INDIANA DEPARTMENT OF TRANSPORTATION

APPROVED MINUTES

April 15, 2010 Standards Committee Meeting

RE: Minutes for the April 15, 2010 Standards Committee Meeting

ADDED REVISED DRAWING 715-PIPE-02 MISCELLANEOUS PIPE DETAILS (SEE COMMENTS AND ACTION)

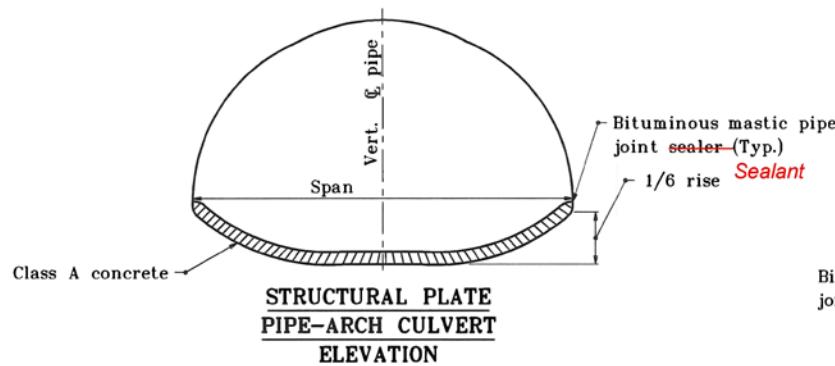
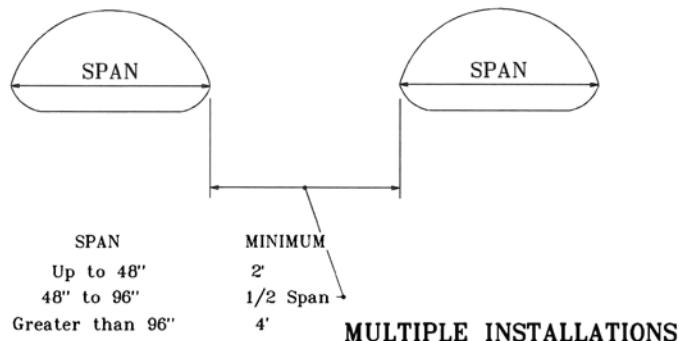
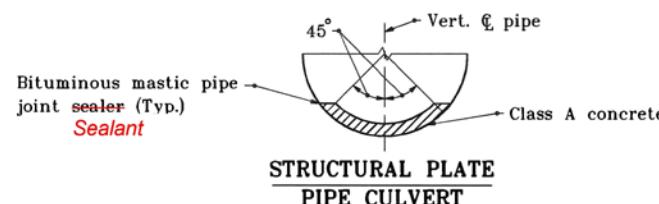
- ① In order to maintain their manufactured shape, all 3" x 1" corrugated steel pipe-arch sections shall have wire ties attached at each end as shown in the detail. The wire ties shall be attached across the largest vertical and horizontal dimension of the pipe-arch. The wire ties shall be installed by the manufacturer and shall remain in place until the on-site installation is complete.
- ② **WWR** Welded wire fabric shall be securely wired to every second circumferential bolt and every twelfth longitudinal bolt.

Note: Revised Drawing 715-PIPE-02 Miscellaneous Pipe Details with these changes has been included in these minutes.

PROPOSED REVISION TO RECURRING PLAN DETAILS 706-B-140d GUARDRAIL TRANSITION, TGS-1 (PAGE 3)

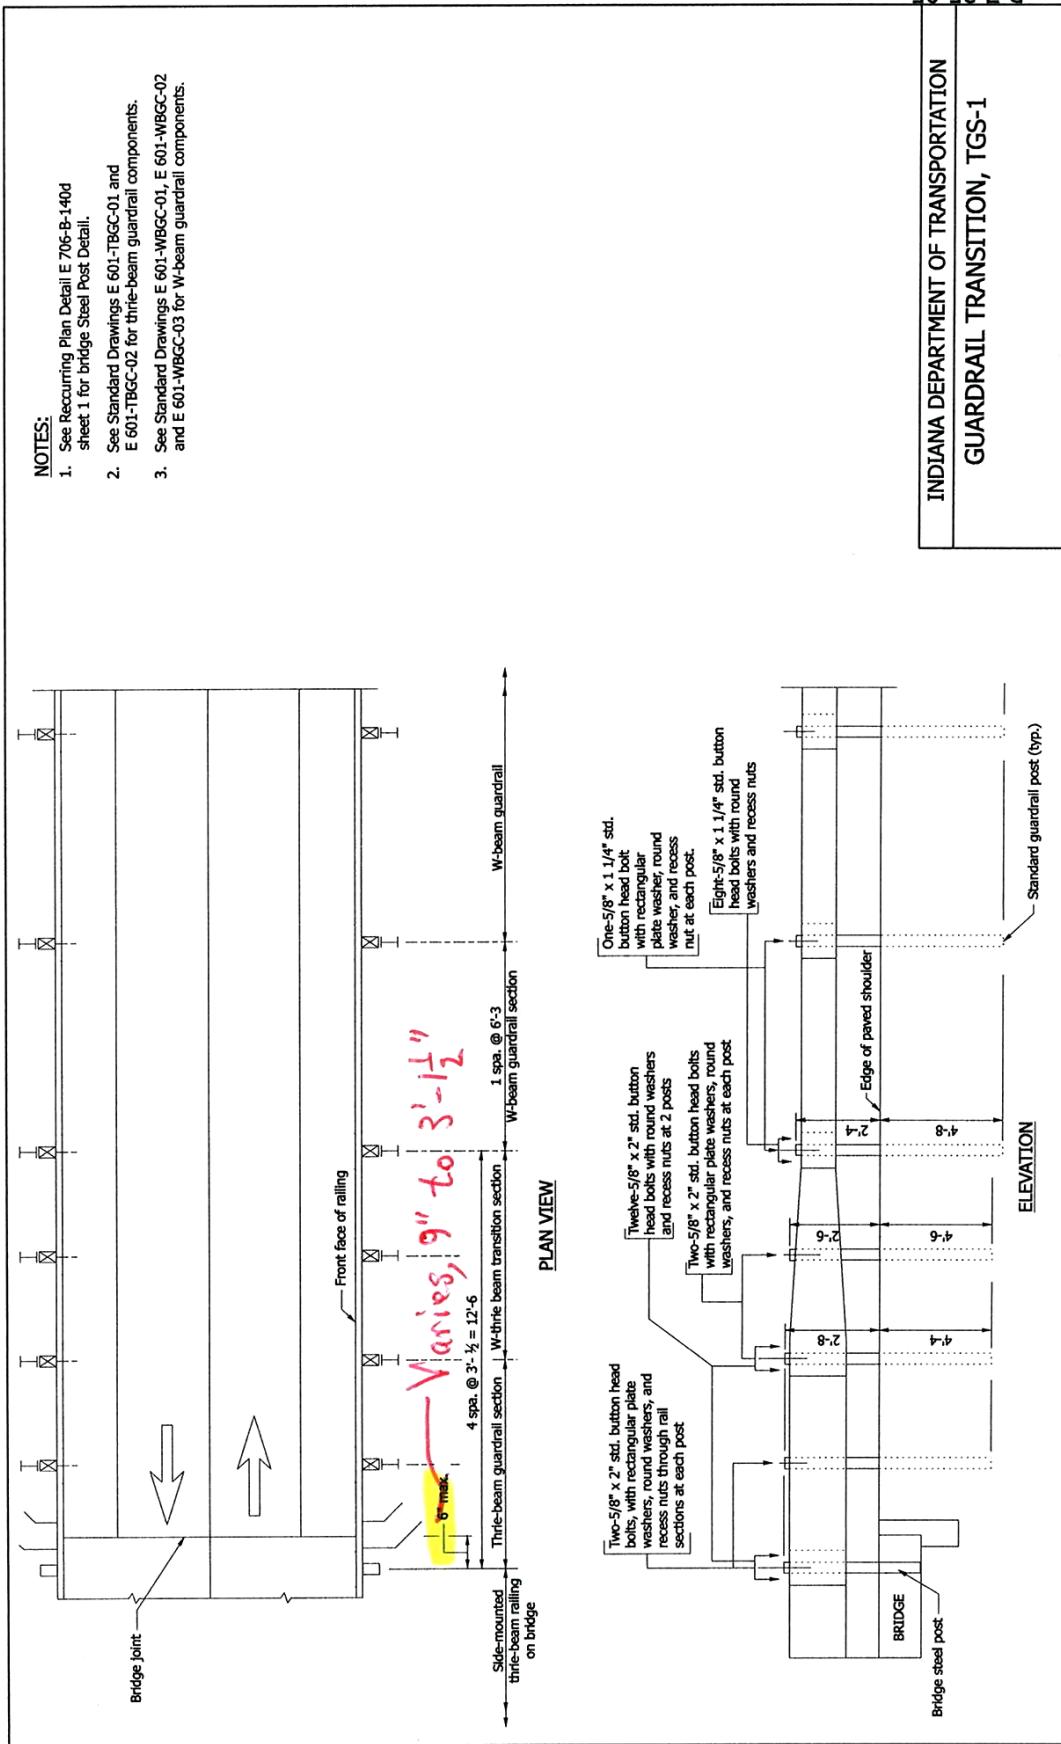
PROBLEM(S) ENCOUNTERED: Guardrail transition TGS-1 approach to a bridge with three-beam side-mounted railing's post spacing is in error. Recurring Plan Detail E 706-B-140d, page 3 of 3, shows the distance from the bridge joint to the first bridge-railing post to be 6 in. maximum. Anchor bolts are required to connect the railing posts to the bridge coping. The bolts must be embedded 2'-10" into the bridge deck. For a structure of greater than 9 deg skew, the inside end of the anchor bolt for the post closest to the joint will penetrate the bridge approach.
